ADDENDUM NO. 3

Contract No.	DA00708
TIP No.:	N/A
Federal Aid No.:	State Funded
WBS Element:	16.401
County:	Dare
Description:	M/V Carteret Credit Dry Dock (CDD)
Letting Date:	November 4, 2026 **(Revised)**

M/V CARTERET
HVAC MODIFICATIONS
COVER SHEET

M/V CARTERET
HVAC MODIFICATIONS
PIPING SCHEMATIC

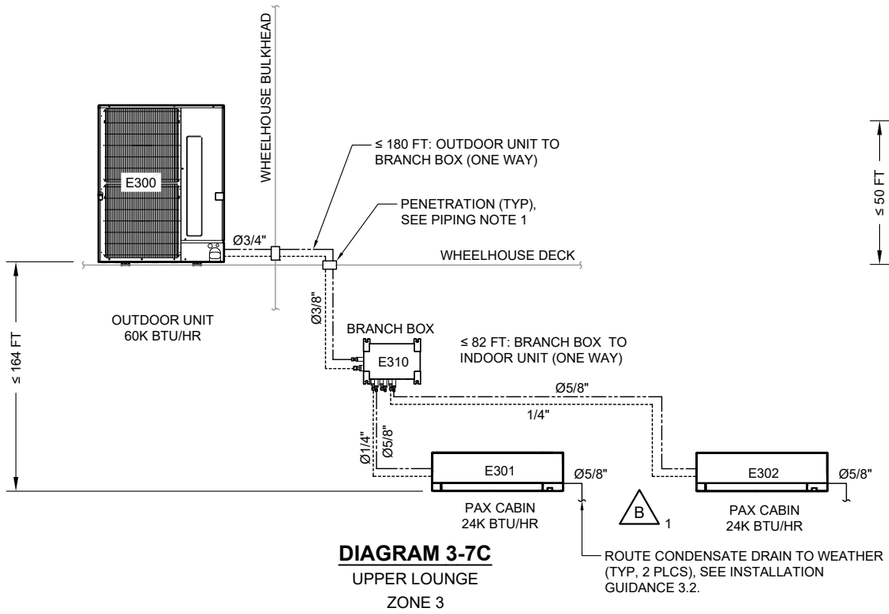
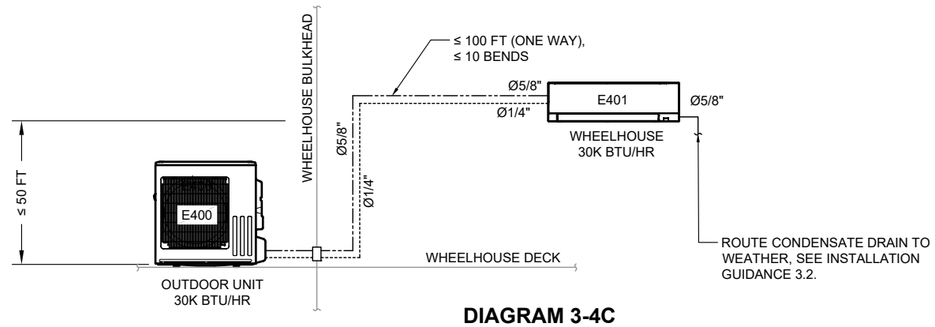
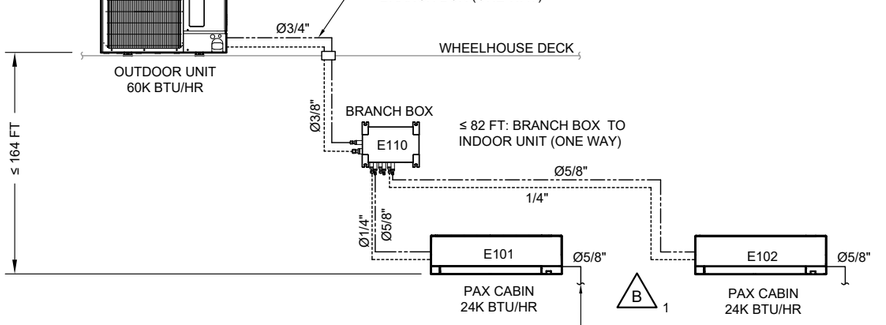
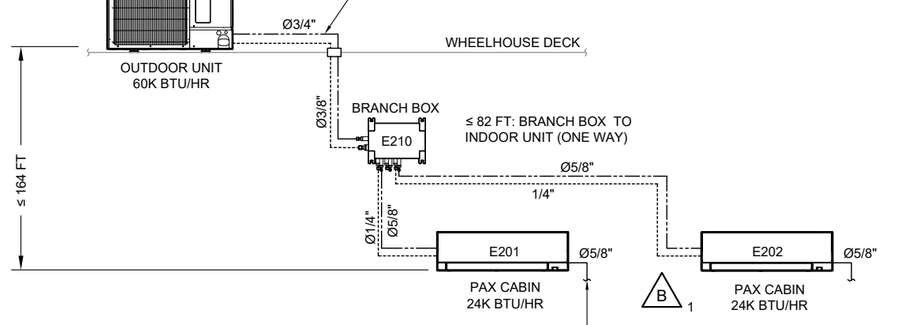
ZONE	REV	DESCRIPTION	DATE	APPD
	-	INITIAL RELEASE	2026/02/27	MSM
SHT 7 SHT 1, 7	A	1. UPDATED ELECTRICAL FEEDER CIRCUITS 2. UPDATED CONDENSATE PUMP CIRCUIT BREAKER	2026/07/29	MSM
SHT 1, 3	B	1. CHANGED MSZ-GX30NL INDOOR UNIT MODELS TO MSZ-GX24NL IN PAX LOUNGES	10/15/2026	MSM

1. **Sheet 17 through 23 "HVAC Modifications, Sheets 1 through 7":** Updated HVAC plan sheets incorporating the revisions detailed on Sheet 1. Replace the original "HVAC Modifications, Sheets 1 through 7, **Revision A**" in their entirety with the attached **Revision B** sheets.
